Access Compliance Report
Public Rights-of-Way
(Curb Ramps)

Intersection ID: 24962	**Main Street: KENLAUREN_TR**	**Cross Street: WILDBRACKEN_CT**	**Location: SW**
ADA ID: 4C3DF2B7AF5A	**Ramp Type: PerpDiag**	**Initial Pass/Fail: Fail**	**Overall Compliance: No** / **Severity Score: 13.75**

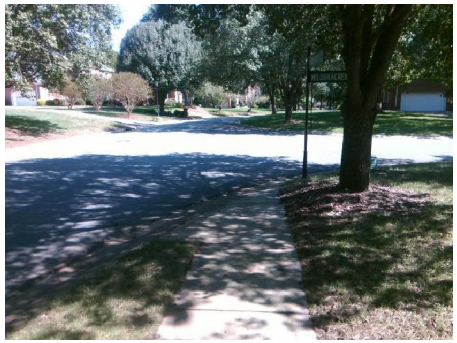
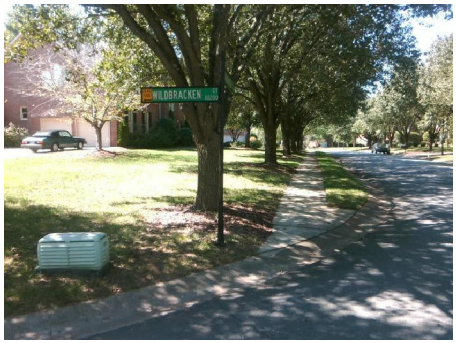
Not Found, R304.2.2, R304.5.3

Compliance	Description	Data	Compliance	Description	Data
N/A	Ramp Length (in)	56.0	No	Ramp Slope (%)	8.5
Yes	Ramp Width (in)	48.0	No	Ramp XSlope (%)	3.7
N/A	Flare Type LT	N/A	N/A	Flare Type RT	N/A
N/A	Flare Slope LT (%)	N/A	N/A	Flare Slope RT (%)	N/A
N/A	Flare Traversable LT?	N/A	N/A	Flare Traversable RT?	N/A
N/A	Landing Length (in)	N/A	N/A	DWS Provided?	N/A
N/A	Landing Width (in)	N/A	N/A	DWS Contrast?	N/A
N/A	Landing Slope (%)	N/A	N/A	DWS Length (in)	N/A
N/A	Landing X Slope (%)	N/A	N/A	DWS Full Width?	N/A
N/A	Landing Curb? (Y/N)	N/A	N/A	DWS Offset (in)	N/A
N/A	Shared Landing?	N/A			
N/A	Gutter Ponding?	N/A	N/A	Gutter Slope (%)	N/A
N/A	Gutter Lip Ht (in)	N/A	N/A	Gutter X Slope (%)	N/A
N/A	Painted X Walk1?	No	N/A	Painted X Walk2?	No
	X Walk 1 Direction	To SE		X Walk 2 Direction	To N
N/A	X Walk 1 Width (in)	N/A	N/A	X Walk 2 Width (in)	N/A
	X Walk 1 Slope (%)	0.3		X Walk 2 Slope (%)	3.9

Remove & Replace Curb Ramp With Two New Directional Ramps or Equivalent.
